From: Alec Richardson <Alec@luxurylandscape.com>
Sent: Wednesday, July 10, 2024 11:01 AM
To: Barry Mock <Barry.Mock@lawrencevillega.org>
Subject: Re: rendering

RZC2024-00058_EMAIL_07102024

P&D RECOMMENDED CONDITIONS

LUXURY LANDSCAPE_05182024

RIGHT ELEVATION

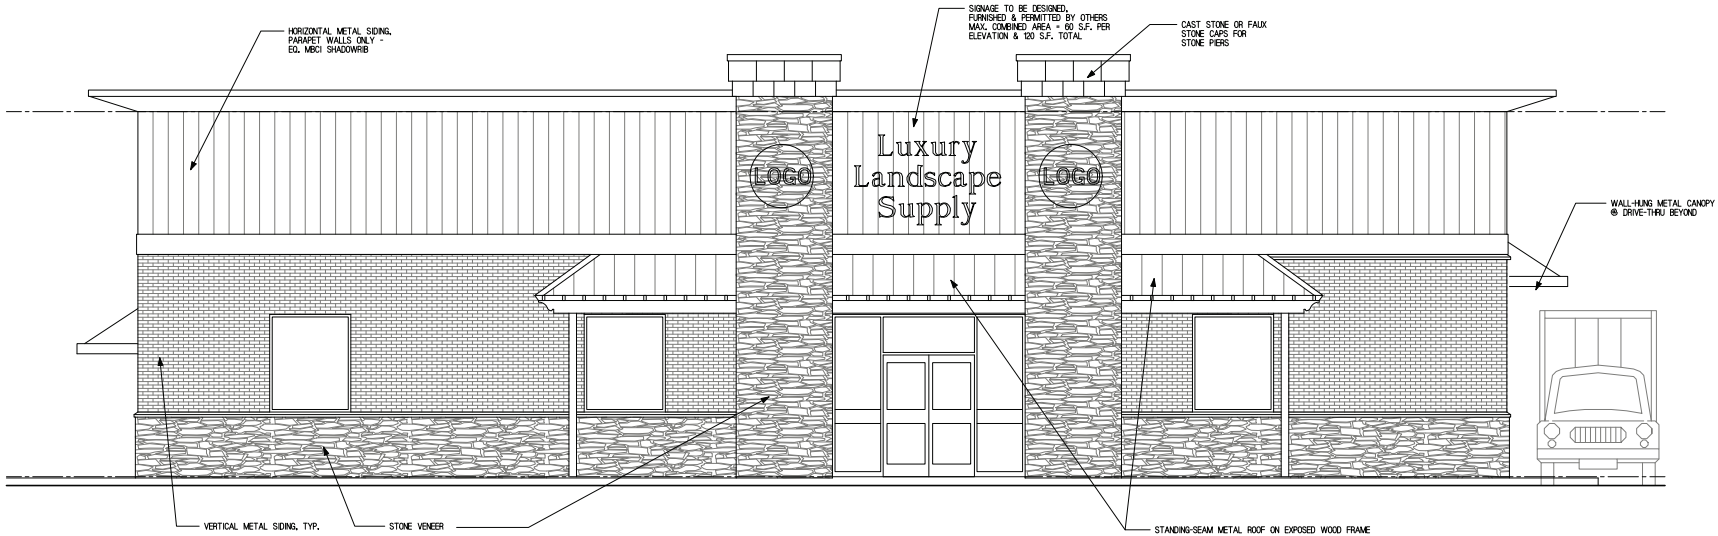
I am ok with the proposed elevation changes. See new attachment with stone at bottom and brick in the middle section. I would like approval for metal in the rear of the building. We might end up doing the 3ft of stone at bottom, but I am just being cautious with our budget.

- 4.** The design of the façades shall meet minimum architectural standards and shall be in accordance with the proposed renderings presented at the July 22 Council meeting. Final designs shall be subject to the review and approval of the Director of the Planning and Development Department. A temporary building shall be allowed for 8 months to allow for a new facility to be constructed on site.
